**GEOMORPHIC EVALUATION OF
PROPOSED SHAFT AND RAMP LOCATIONS
YUCCA MOUNTAIN HIGH LEVEL WASTE SITE**

Draft Report No. LLNL/NRC-NNWSI-CRP-87/88-YM1

Submitted by: Charles (Rus) Purcell

January 1988

FIGURE 1 LOCATION MAP

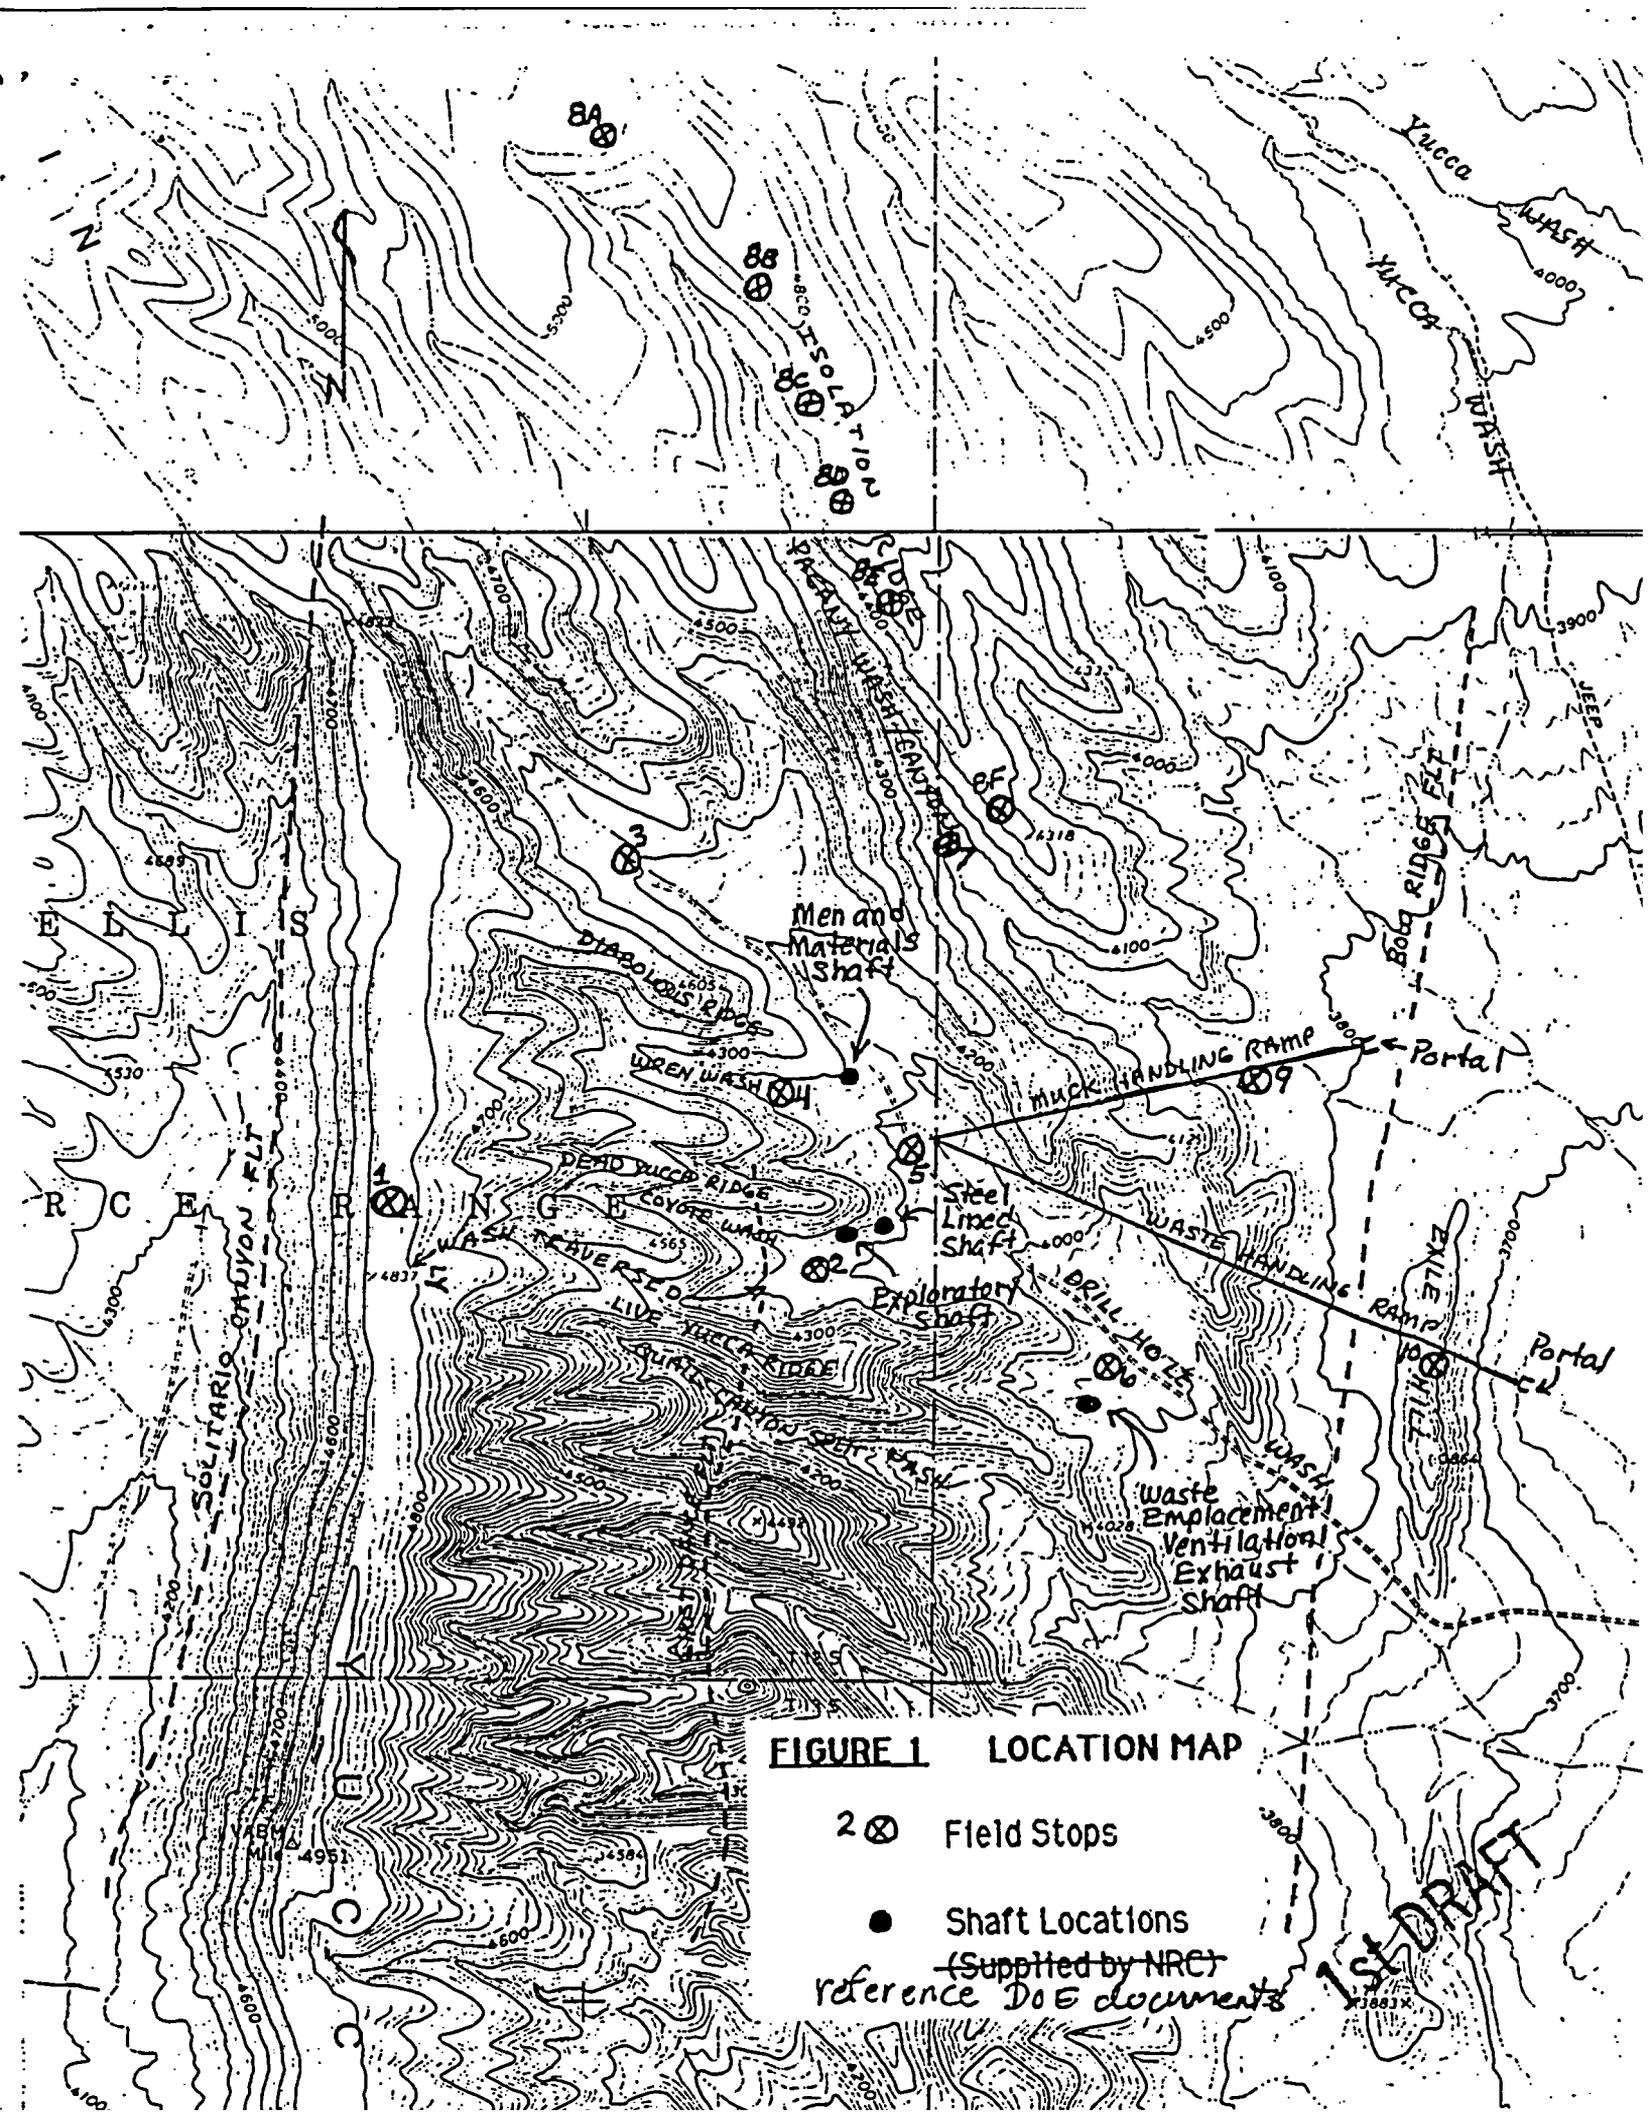
This area has been greatly altered by man making it difficult to estimate its natural state. The area is about 300 meters west of the location of the proposed ES and 395 meters west of the SLS (Figure 1). Small debris flow deposits are found at the mouth of the traversed wash and Coyote Wash. These deposits are about 2 to 3 meters thick (above the active wash) with a predominantly coarse, bouldery nature. There were no noticeable debris deposits in the area directly adjacent to the proposed shafts. All the debris deposits are dumped upstream of the shaft locations.

Based on the supplied maps (Figure 1), the exploratory shaft is estimated to be approximately 9 to 12 meters above the active wash. This vertical distance is interpreted to be adequate to avoid any hazards from flooding and debris flow deposits coming from the tributaries to the west or from Drill Hole Wash. However, an important aspect that becomes evident is the horizontal distance from the active channel in Coyote Wash to the actual subsurface shaft, i.e. distance A on the following diagram.

The ES, and SLS are located on the southern slope of Dead Yucca Ridge near Drill Hole Wash, and the MMS shaft is located on the southeastern slope of Diabolous Ridge near Drill Hole Wash (Figure 1). All three locations are about 9 to 12 meters above the active wash. Field observations suggest these locations are adequate as far as the hazards of flooding and debris deposits are concerned. However, care should be taken during construction and operation to protect against lateral erosion.

The WEVES is located in the drainage channel of an unnamed tributary to Drill Hole Wash immediately south of the tributary containing the ES (Figure 1). Field and map observations show this location to be no more than 6 meters above the active channel of Drill Hole Wash. This location is marginally adequate as far as the hazards of flooding and debris deposits. Furthermore, the location is essentially in the channel bottom and should probably be reconsidered for this reason alone.

Careful characterization of the potential flooding at the WEVES location is necessary to adequately evaluate the proposed shaft location. Estimates of the maximum flooding potential and the flooding potential associated with the theorized stream capture of Yucca Wash by Drill Hole Wash, based on drainage basin size and increased discharge should be presented. If the results of these analyses confirm the likely potential of flooding at the shaft location, DOE should consider relocating the WEVES farther upslope, out of the channel of the unnamed drainage.

The MHR portal is located southeast of the end of Isolation Ridge on an alluvial fan coming from Pagany Canyon, and west of the major influence of Yucca Wash (Figure 1). The ramp extends westerly across the alluvial fan, under the ridge separating Pagany Wash from Drill Hole Wash to a point near the center of Drill Hole Wash. Field observations suggest the site is probably adequate as far as flooding from Yucca Wash, however, the potential hazards of flooding, deposition, and erosion across the alluvial fan coming from Pagany Canyon suggest the site needs to be carefully characterized.

FIGURE 2 ALLUVIAL DEPOSITS NEAR THE MOUTH OF PAGANY CANYON

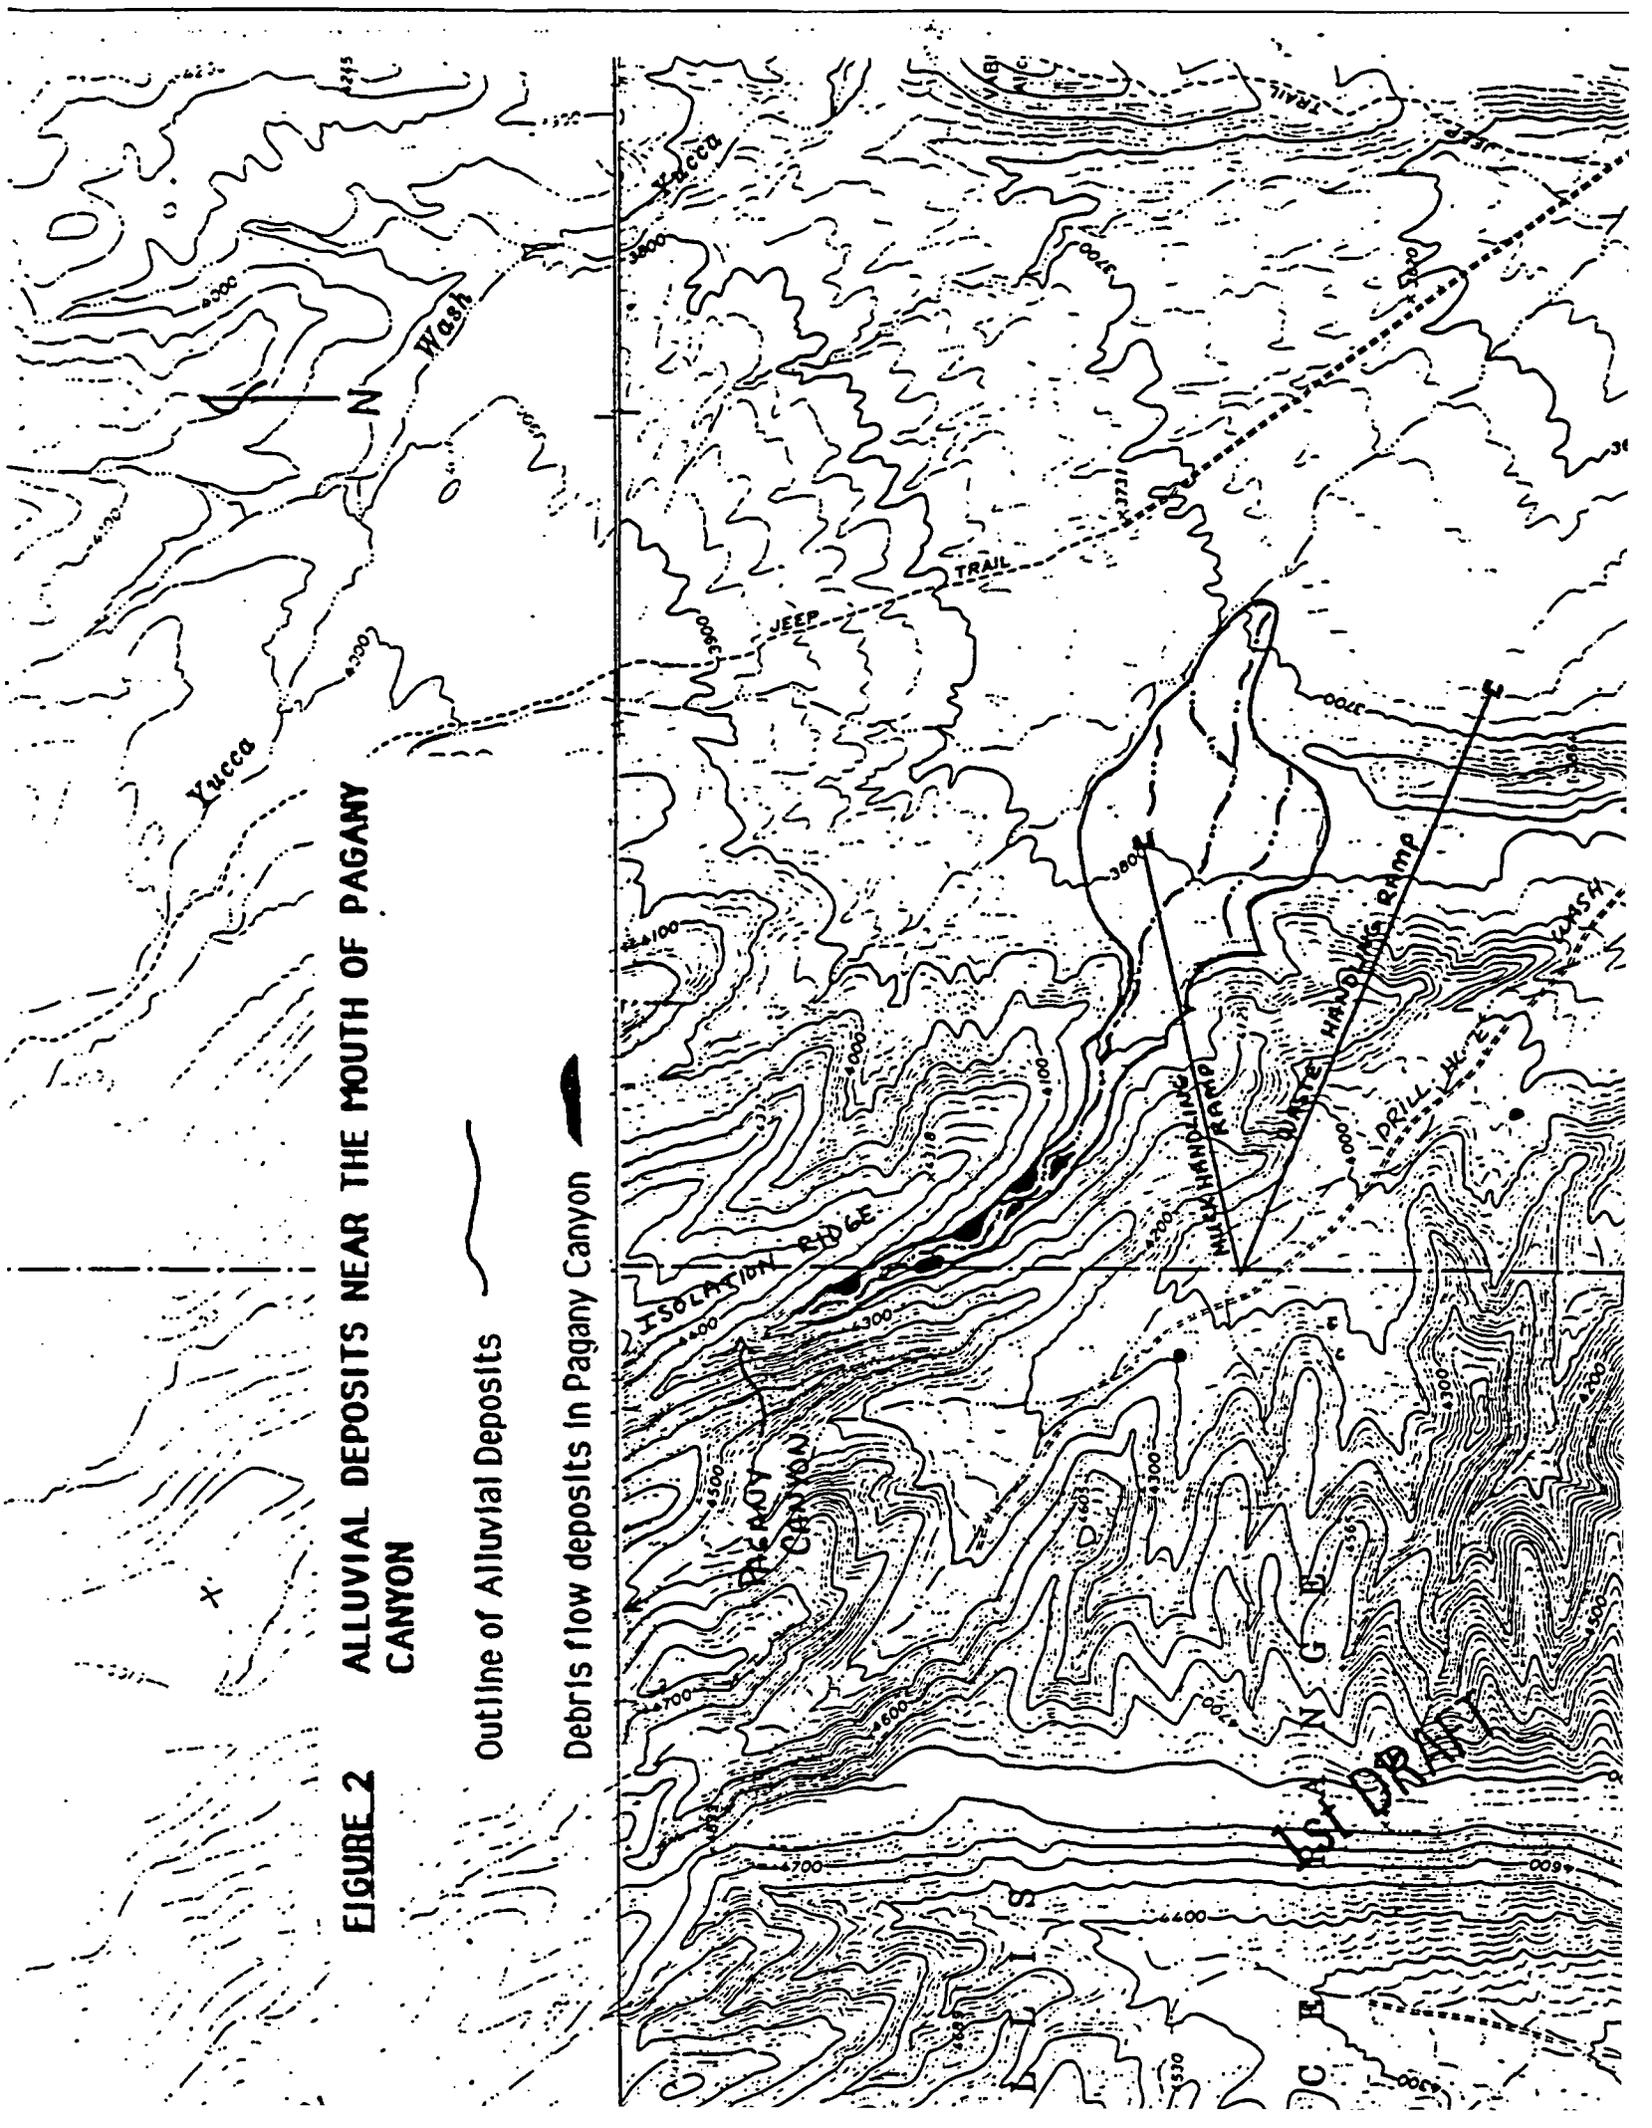
Pagany Canyon is very deep (105 to 120 meters) at its headwaters and is steep sided with boulders and grasses covering most of the slope. The channel bottoms primarily in thin (?) fluvial material with some outcroppings of bedrock in and adjacent to the active channel. Minor amounts of valley fill material are present in the upper reaches of the wash and, where present, are probably best described as colluvial mantle and not debris flow deposits. The area is predominantly one of present day erosion. Eroded materials are transported down valley and primarily deposited as alluvial fan material at the mouth of Pagany Canyon

(Figure 2). These characteristics are applicable to the entire upper reaches that were observed from 6 Stops (labeled 8A through 8F, on Figure 1) going downslope (southeast) along Isolation Ridge from the headwaters to the nose of the ridge.

FIGURE 3 THE PATTERN OF FLOOD HAZARD ON A TYPICAL ALLUVIAL FAN IN THE WESTERN UNITED STATES (From Cooke and others, 1985)

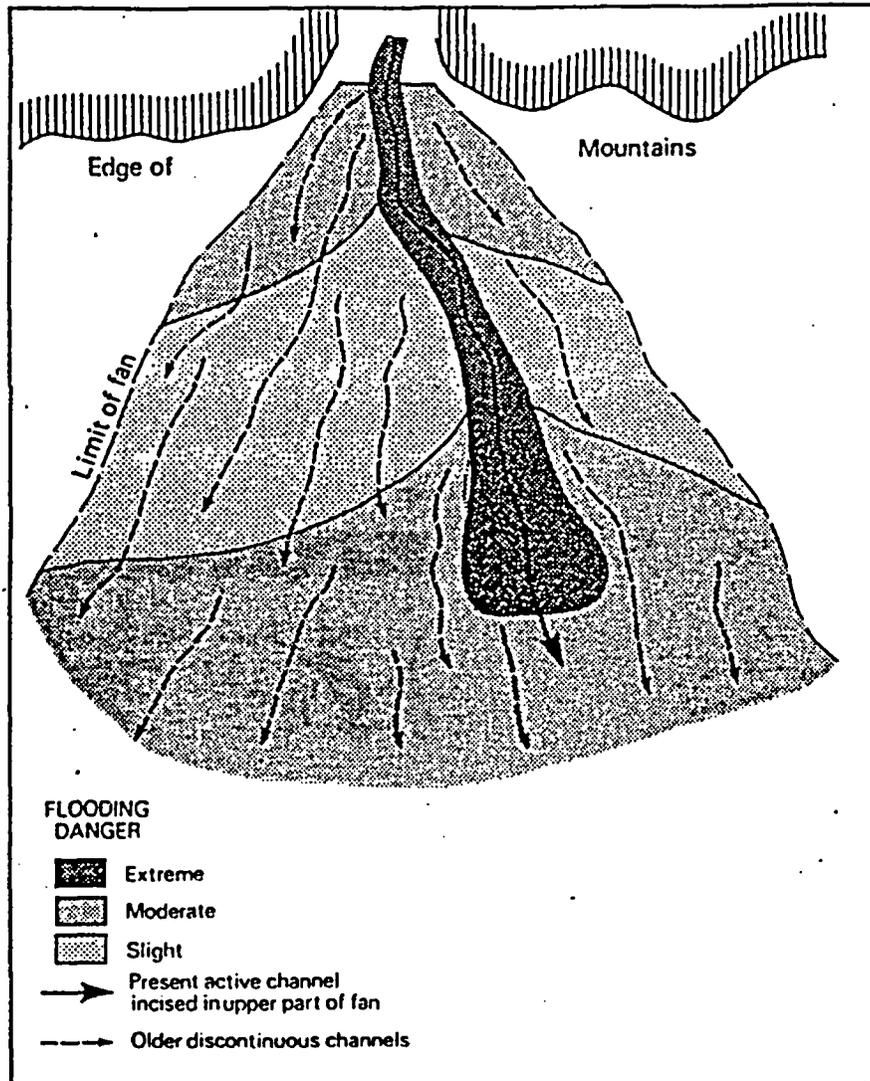
Data presented by Cooke, Brunnsden, Doornkamp, and Jones (1985) regarding zones of flooding on a typical alluvial fan in the western United States shows the MHR portal to presently be in an area of moderate to slight flooding danger (Figure 3). The characteristics of the alluvial fan coming from the mouth of Pagany Wash suggest the fan is relatively young (< 10,000 years old) and probably still periodically building. Alluvial fans build in pulses of alluviation which typically migrate across the fan surface. This migration of the main, active channel, suggests the potential exists for the MHR portal area to also be exposed to extreme flooding danger during the evolution of the alluvial fan in the next 10,000 years of geomorphic development.

FIGURE 4

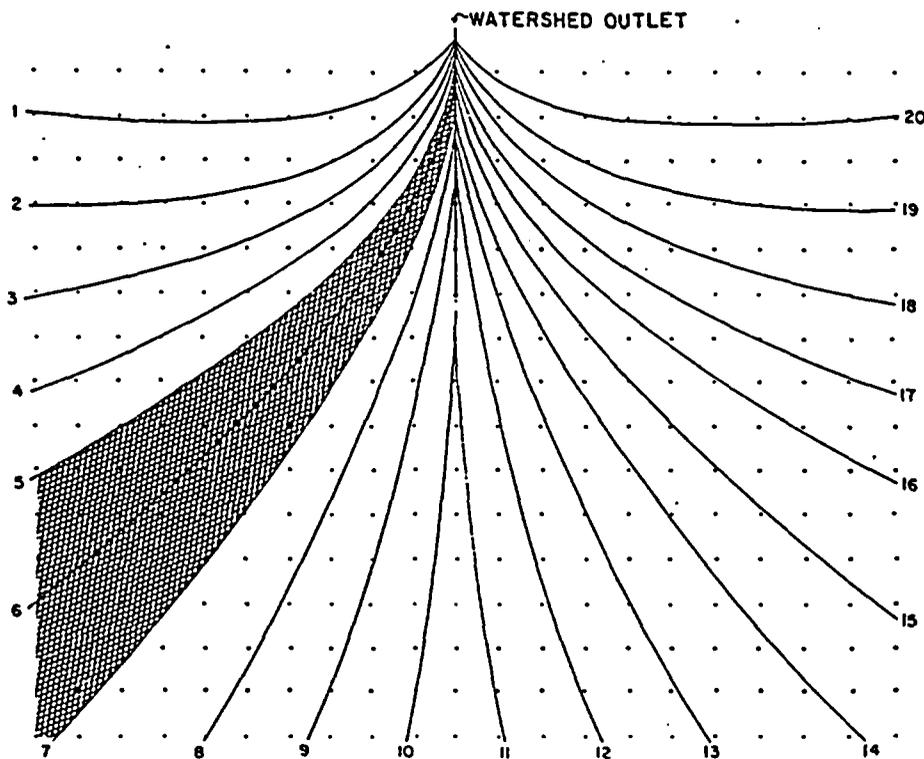
Schumm, Mosley, and Weaver (1987) present theoretical data defining probabilities of erosion and deposition at various segments of an alluvial fan system. These segments include 1) entire fan surface, 2) fan apex, 3) upper midfan, 4) lower midfan, and 5) toe. The probability matrices can be used to identify hazardous areas on evolving alluvial fans (Figure 4 and Tables 1 through 3). The underlying factor shown by these data is that erosion and deposition are ongoing and changing their location throughout the fan building process. These theoretical results further confirm the potential for erosion and deposition across the entire fan surface. Therefore the potential for erosion into the underlying shaft (I have no data to suggest the depth to the shaft at various locations along its length) and deposition and surface flooding at the MHR portal are factors that need to be carefully evaluated.
